WILPINJONG EXTENSION PROJECT

RESPONSE TO SUBMISSIONS

Figure 1a

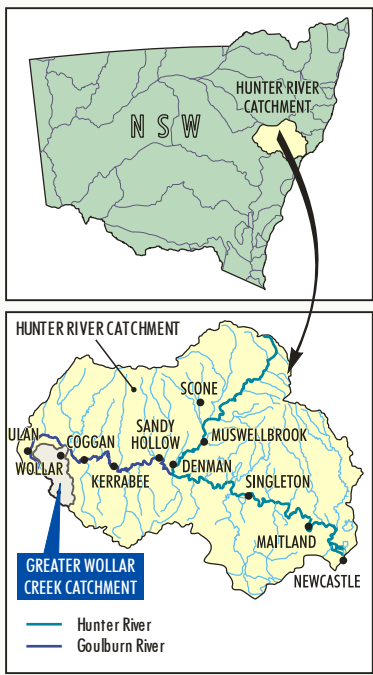
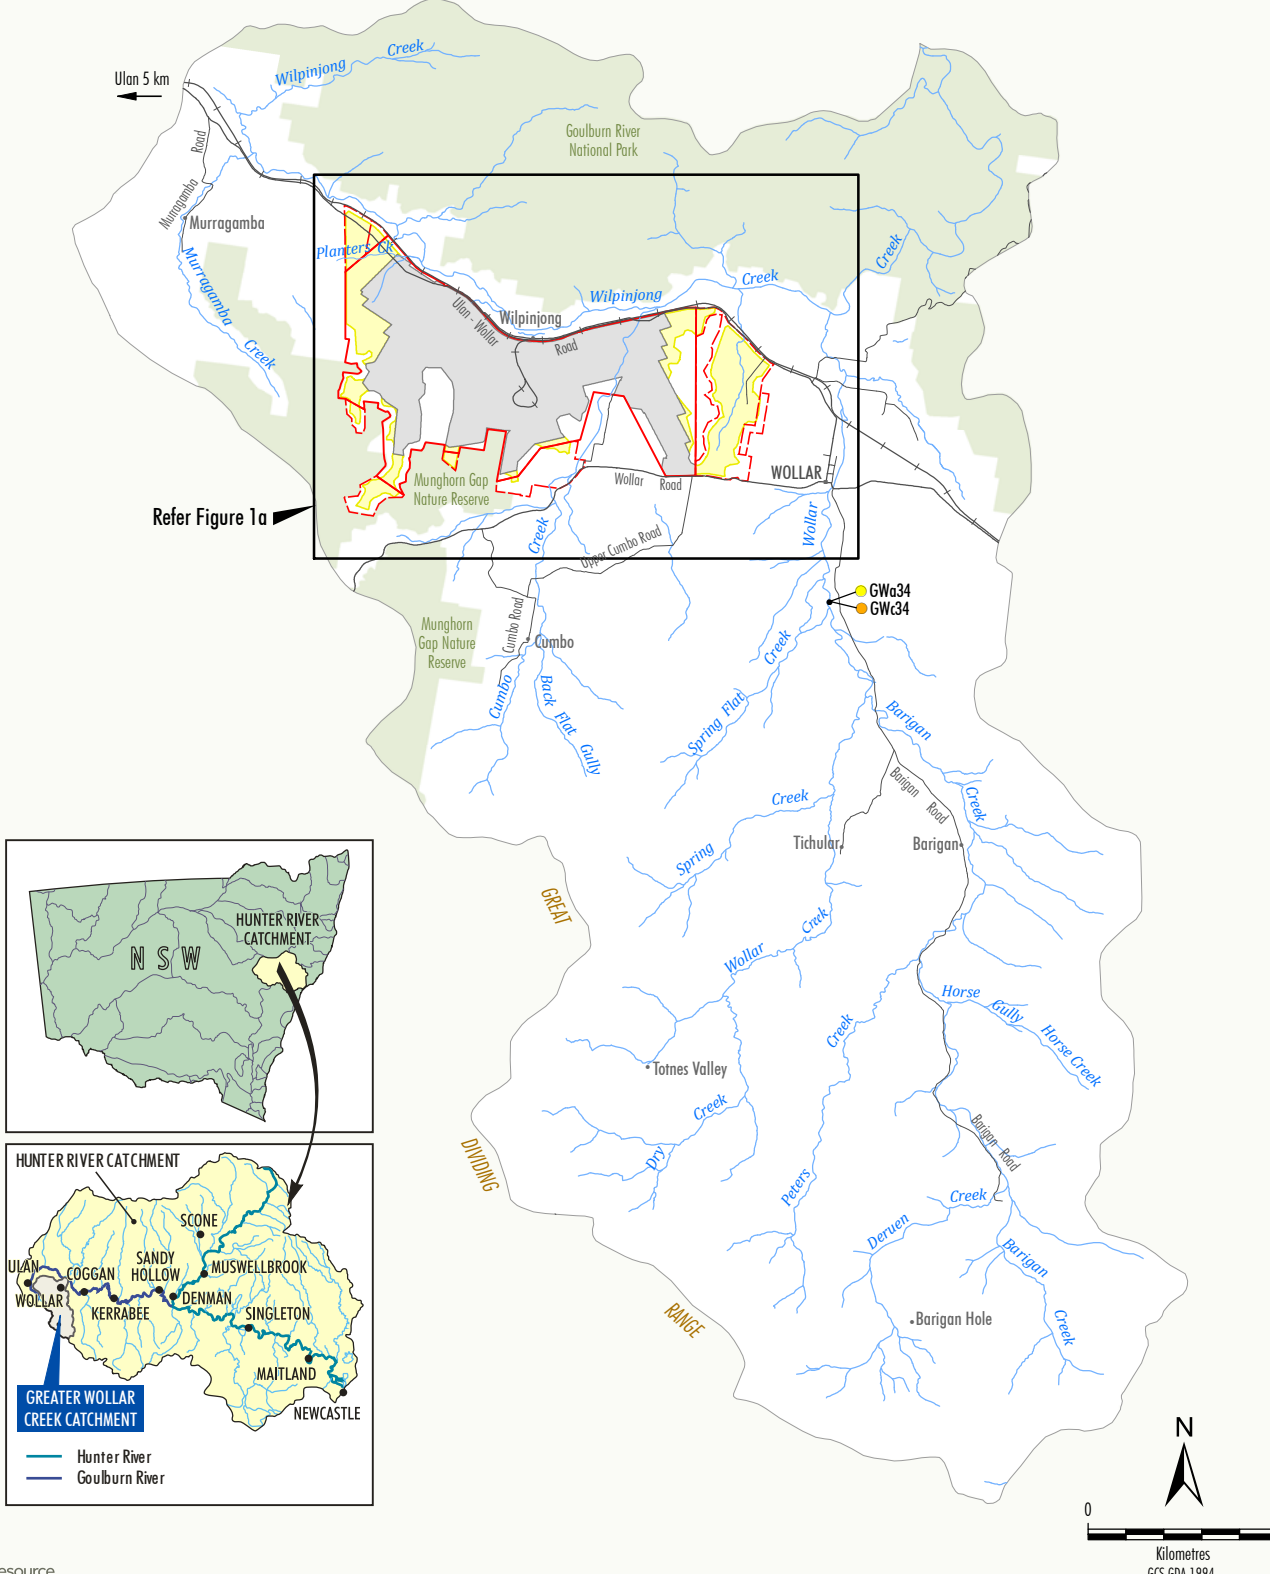
DPI Water specifically requested supplementary information be provided *to demonstrate that water quality impacts will be within Level 1 impacts, as defined in the AIP*. DPI Water (18 March 2016) has requested that WCPL ... *provide descriptive detail to better understand the drivers for the elevated and rising salinity trends in the shallow groundwater and the salinity increase along Wilpinjong Creek*.

Additional recent monitoring data and some further discussion is provided in Appendix D and supports the conclusion presented in the EIS that the water quality impacts will be within the Level 1 minimal impact considerations defined in the NSW Aquifer Interference Policy (AIP) (NSW Government, 2012).

Figure 2

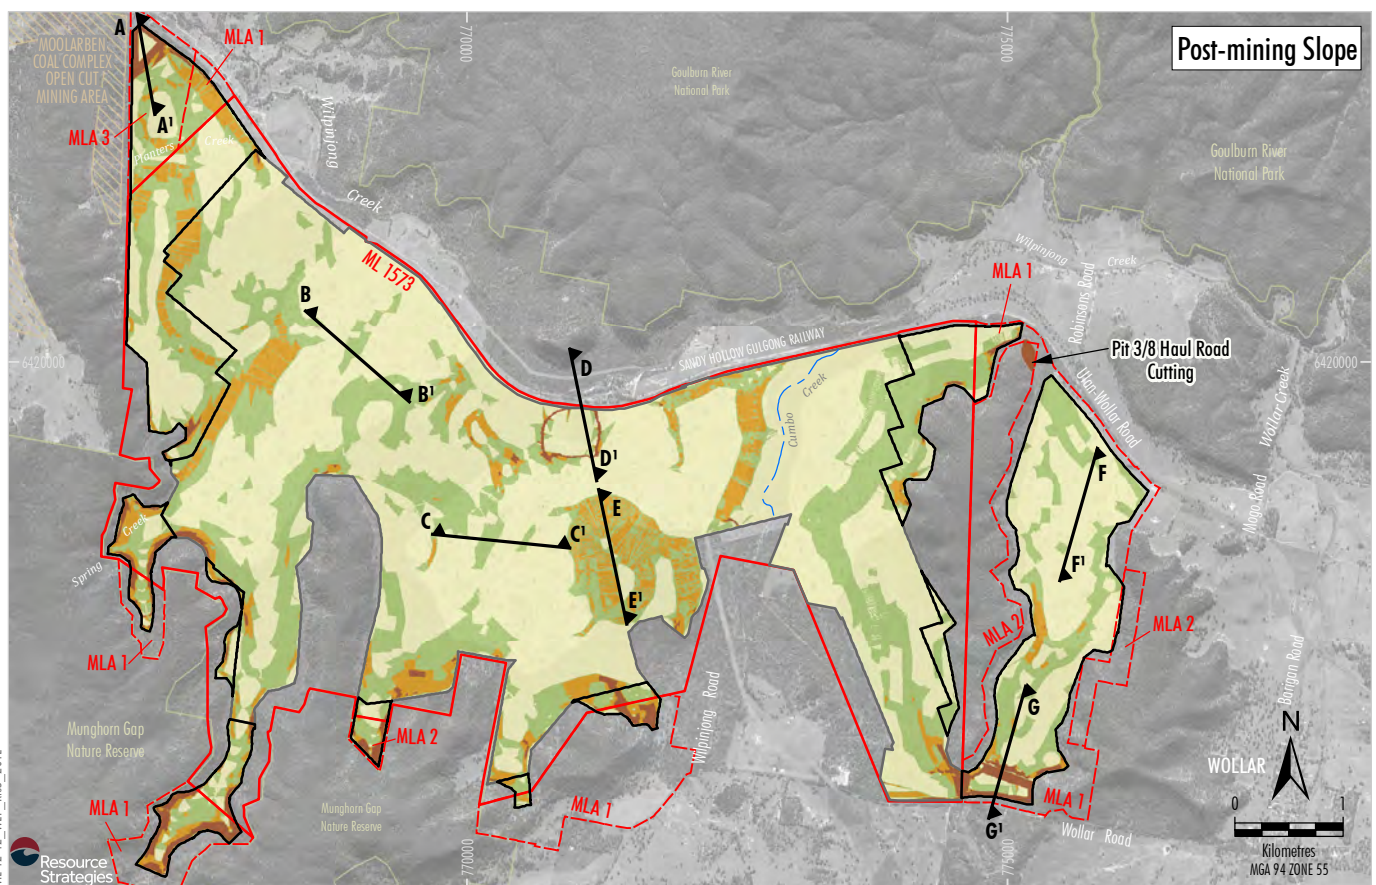
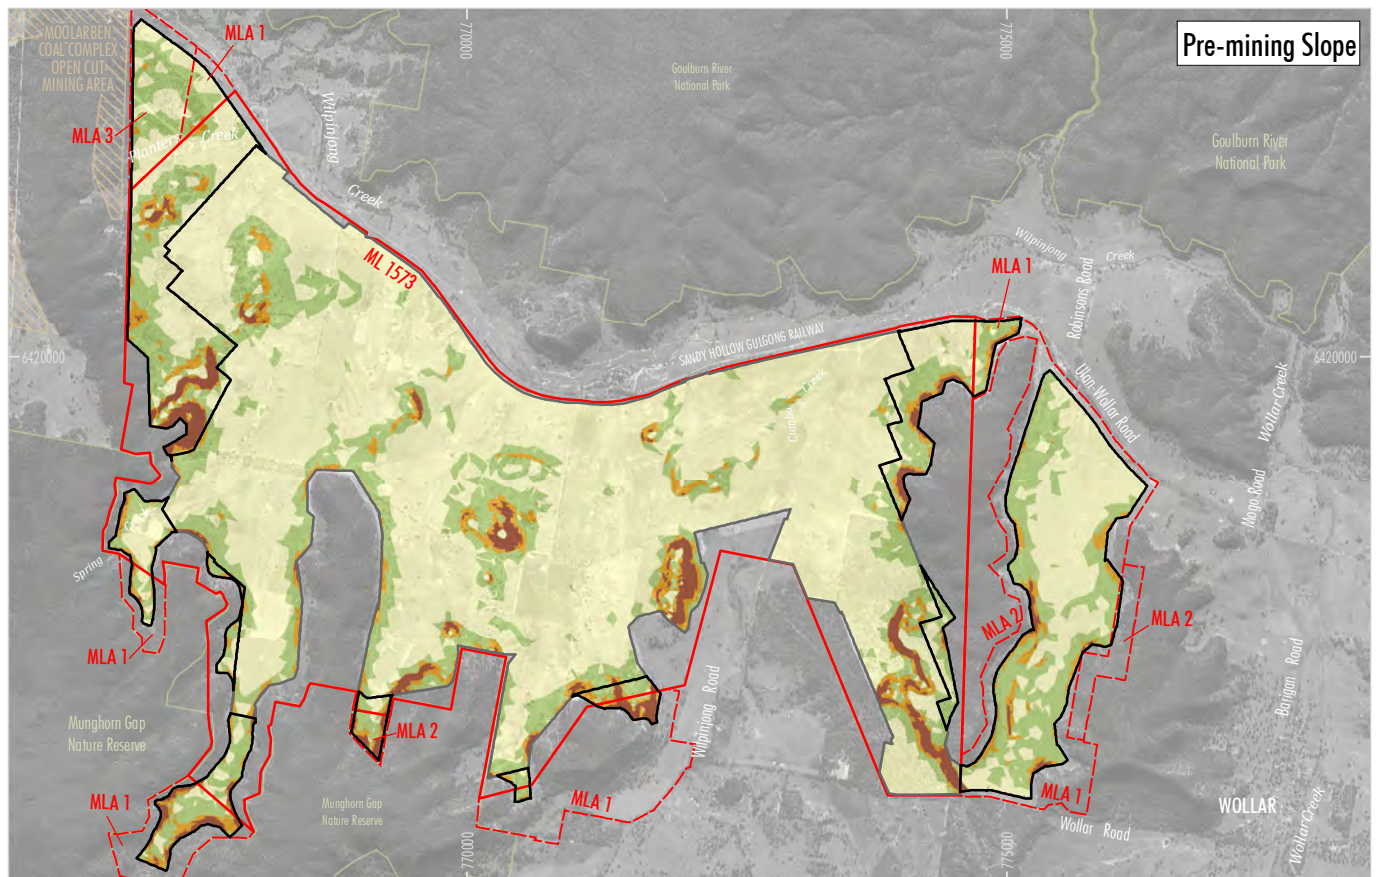
The DRE requested further detail in regards to final landform design, including how similar landscape features as evident in surrounding landscapes had been incorporated into the post-mining landform design.

In the open cut and contained infrastructure area, pre-mining elevations generally range from approximately 350 to 440 m AHD and elevations on the conceptual final landform are also in the same range (Figure 2). The conceptual final landform elevations lie wholly within the range of natural topographic variation in the area.

The in-pit elevated waste rock emplacement would have a final elevation of up to approximately 440 m AHD (Figures 2 and 3). The rehabilitated elevated waste rock emplacement would be consistent with the range of natural elevations in the open cut area pre-mining (Figure 2).

Figure 1: Comparison of estimated PM_{2.5} emissions for all key mining plant

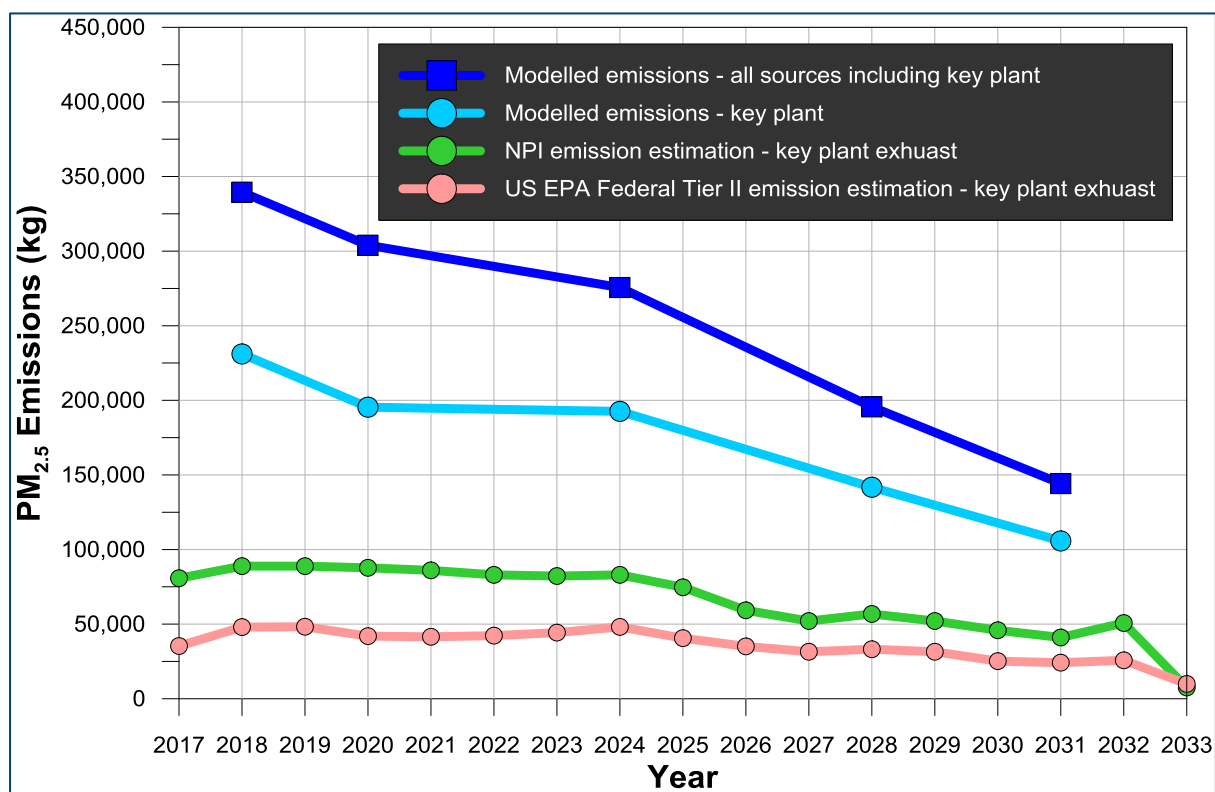
The EPA has raised a concern that emissions of particulate matter from diesel engines have not been adequately quantified. The EPA recommended estimating these diesel emissions and detailing approaches to minimising emissions from diesel plant and equipment.

The total PM_{2.5} emissions modelled in the AQA are compared with the estimated diesel exhaust PM_{2.5} emissions for the Project in total (see **Figure 1**) and with only the haul truck activities (see **Figure 2**). The figures show that the estimated diesel exhaust PM_{2.5} emissions represent between approximately 23 to 41 % of the modelled PM_{2.5} emissions for all key mining plant and between approximately 22 to 27 % of the modelled PM_{2.5} emissions for haul truck activity.

Figure 1
Wilpinjong Creek Electrical Conductivity and Rainfall

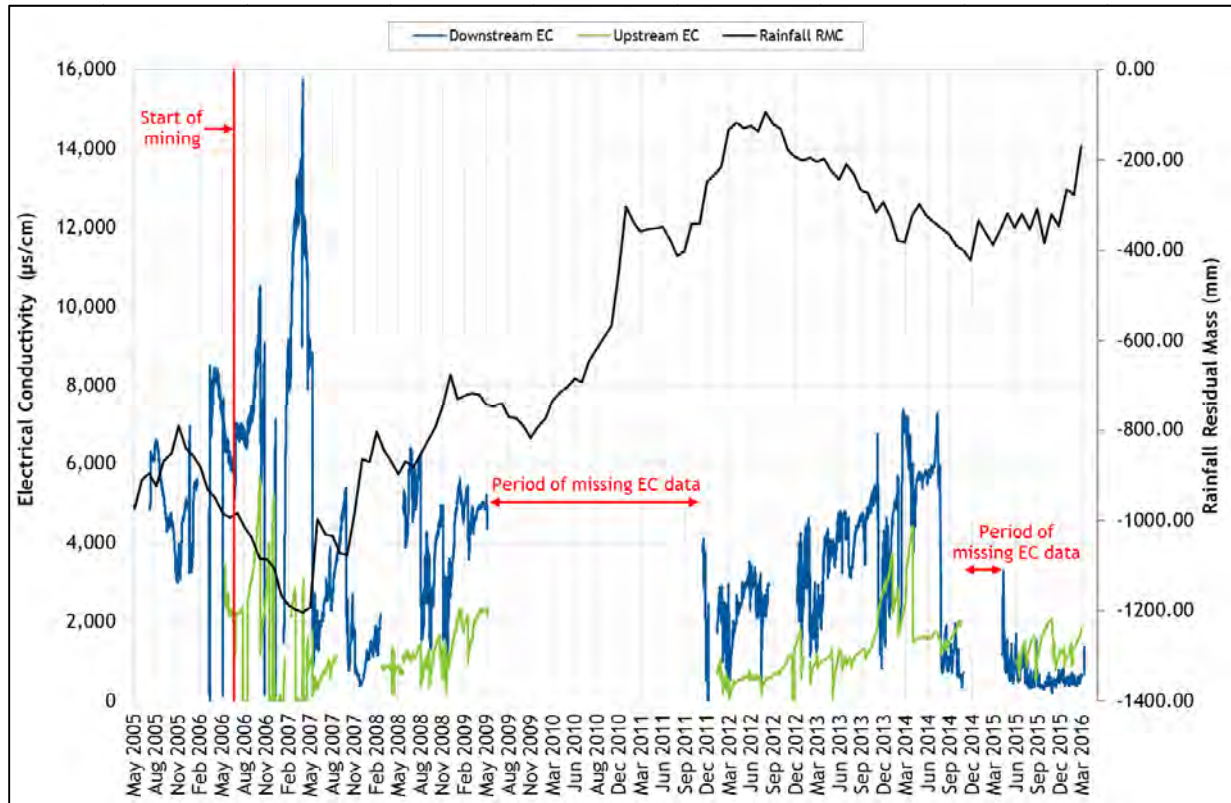
DPI Water and the IESC have raised concerns regarding the potential impacts of the Project on downstream water quality in Wilpinjong Creek. The primary basis for this concern is a perceived recent rising salinity trend along Wilpinjong Creek. DPI Water has also noted a recent rising trend in salinity of two bores maintained by the Department on Wollar Creek (GW273100 and GW273101), located about 3.6 km east of the nearest current workings. Figures 1a and 1b show relevant WCPL groundwater monitoring sites and the above DPI Water monitoring sites.

Figure 1 indicates that the observed salinity increase along Wilpinjong Creek in the period January 2012 to September 2014 is well within observed historical climatic variation and has correspondingly decreased both upstream and downstream of the mine since September 2014 in response to a period of increasing rainfall. Rising salinity trends occurring in 2006 – 2007 and 2013 – 2014 clearly correspond with extended periods of lower rainfall as evidenced by the falling Rainfall Residual Mass Curve (Figure 1). In addition, the period of record shows a very clear trend that salinity upstream is lower than downstream since the commencement of monitoring. This is likely due to the influence of higher EC levels in Cumbo Creek, which joins Wilpinjong Creek between the two stations (WRM Water and Environment, 2015).

Figure 3
Electrical Conductivity in Alluvial Groundwater Monitoring Bores

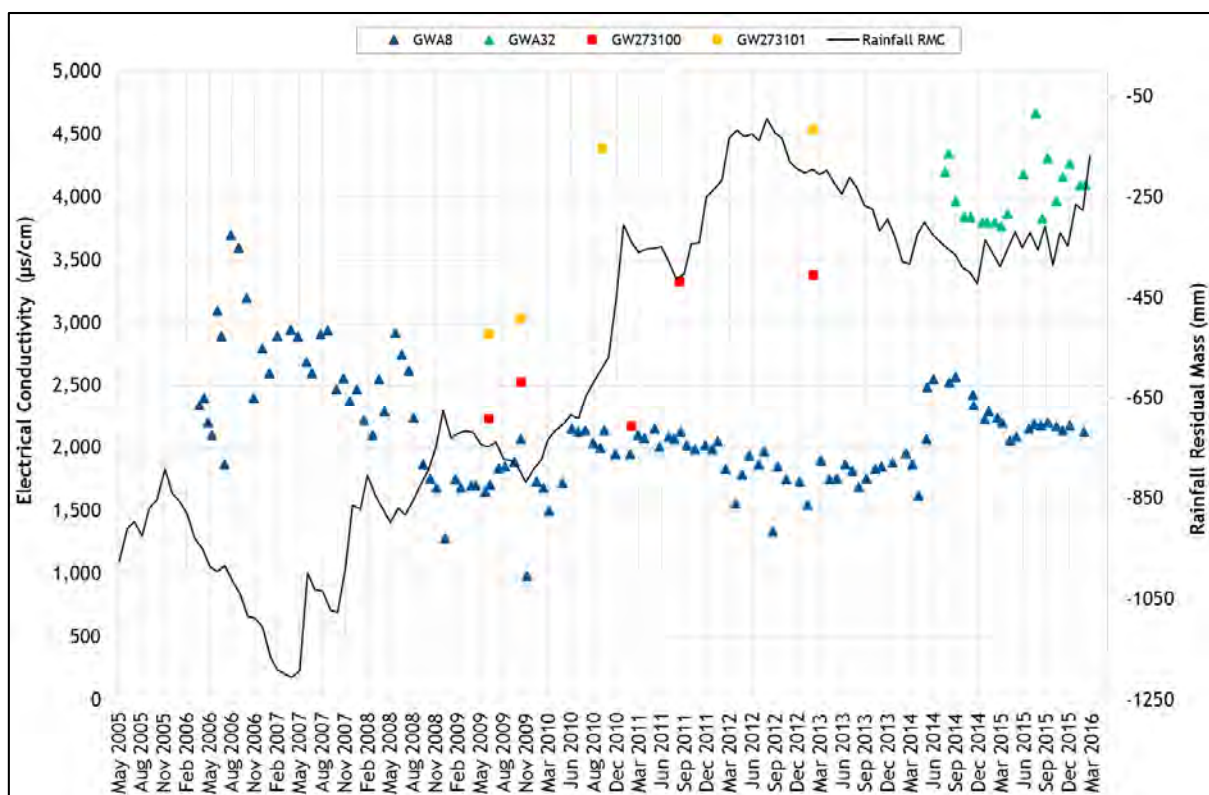
DPI Water also identified an increase in salinity at two bores maintained by the Department on Wollar Creek (GW273100 and GW273101) in the period 2009 to 2013. Both bores are located approximately 2 km east of the Project and 3.6 km east of the nearest current workings in Pit 7 and are up-gradient from the mine, upstream of the Wilpinjong Creek confluence on Wollar Creek which flows generally northwards in this section of the stream.

The increase in salinity at the DPI Water monitoring bores are not reflected in the monitoring results for the nearby WCPL monitoring bores. In addition, the long-term records for GWA8 illustrate responses in EC to rainfall trends and do not illustrate any rising trend that could be attributed to mining effects. The monitoring results at DPI Water monitoring bores are generally consistent with the range of temporal changes in groundwater quality described in Section 3.9.3 of the Groundwater Assessment (HydroSimulations, 2015), which states (emphasis added):
